Elk Hills Class I NH wells – Aquifer Exemption-Related Background information

The EPA Class I UIC permit expired in February 2011. Elk Hills submitted a timely application for renewal. We issued a letter of administrative completeness for the renewal application, and then issued several rounds of technical review comments. We also issued an extension of the original permit keeping it valid until a renewal permit was issued.

As part of the technical review it was discovered that the injection wells (which inject Class I fluids into the Tulare Formation) are located outside the lateral and vertical boundaries of the Tulare Formation that was exempted under the MOA.

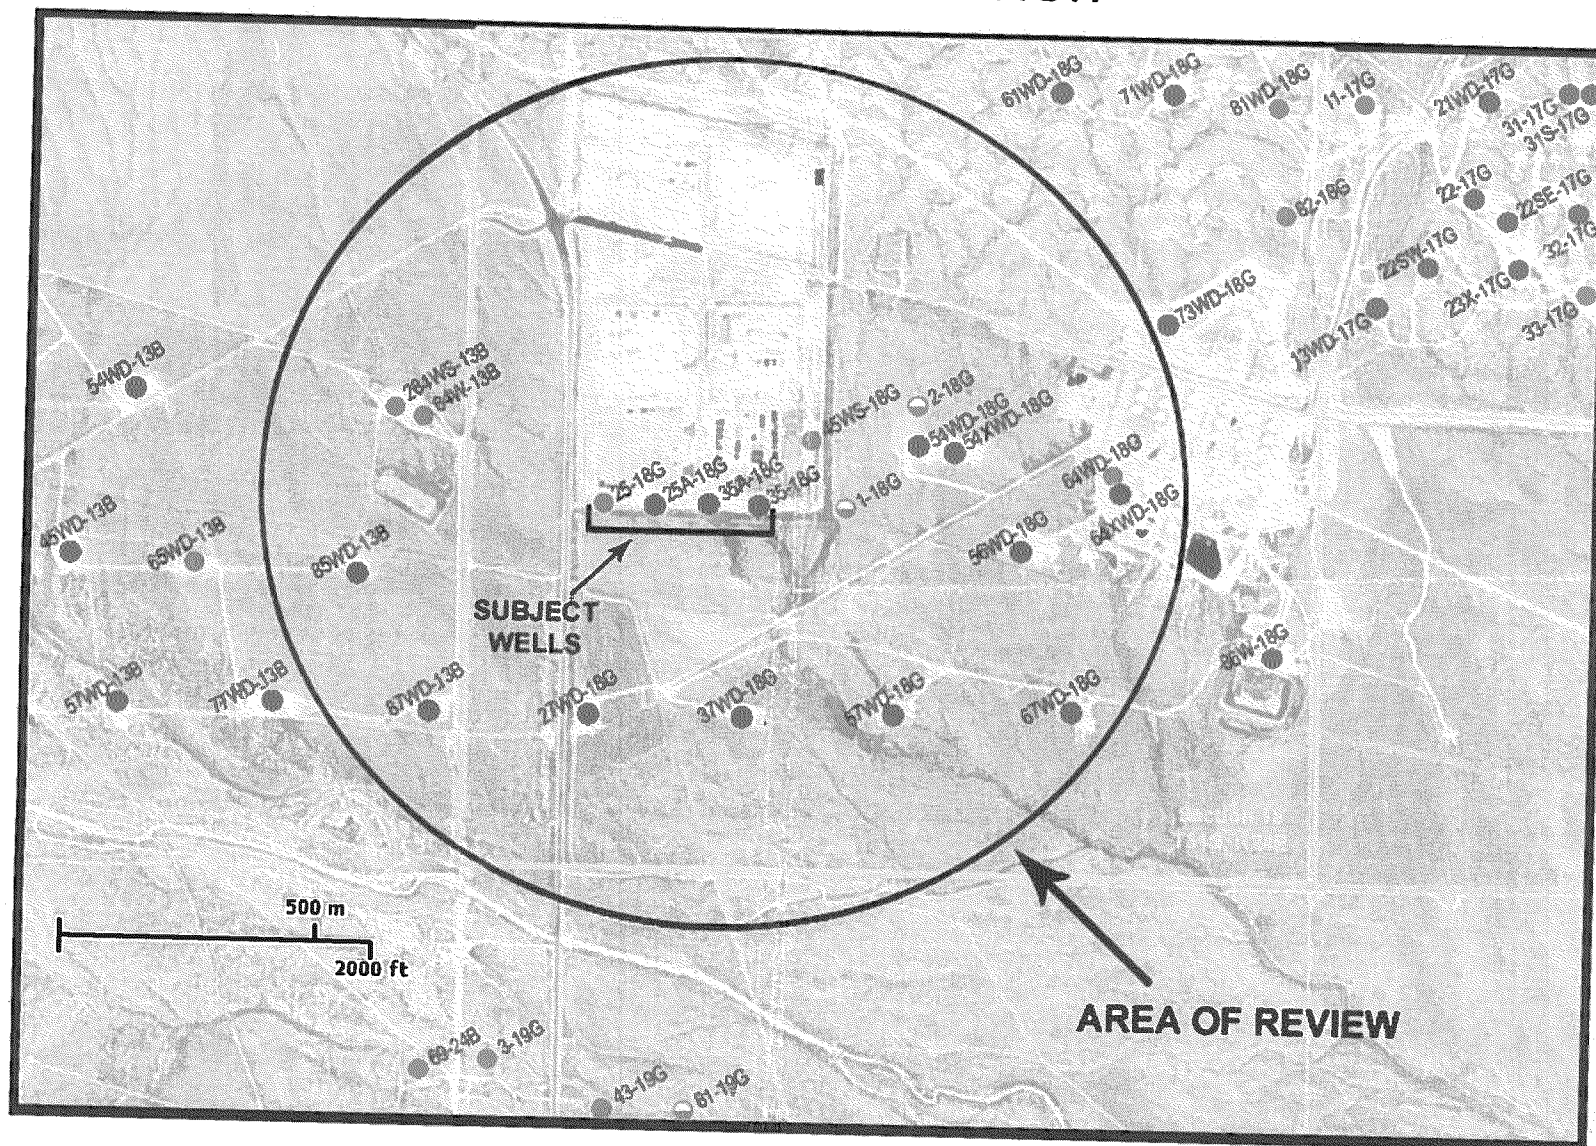
The commenter expressed the concern that the Tulare formation, which is the proposed injection zone, is not an exempt aquifer outside the boundaries of the Elk Hills oilfield and is therefore an USDW. It would be contaminated by off-site migration of injected fluids.

The Tulare formation is not an USDW outside of the boundaries of the Elk Hills field at this location because it is an exempted aquifer in the Buena Vista Front area of the Buena Vista oilfield, which directly adjoins the Elk Hills oilfield to the south. In addition, numerous calculations using a variety of waste plume geometries and formation characteristics have demonstrated that even under significantly less favorable conditions, the waste front will not migrate off-site.
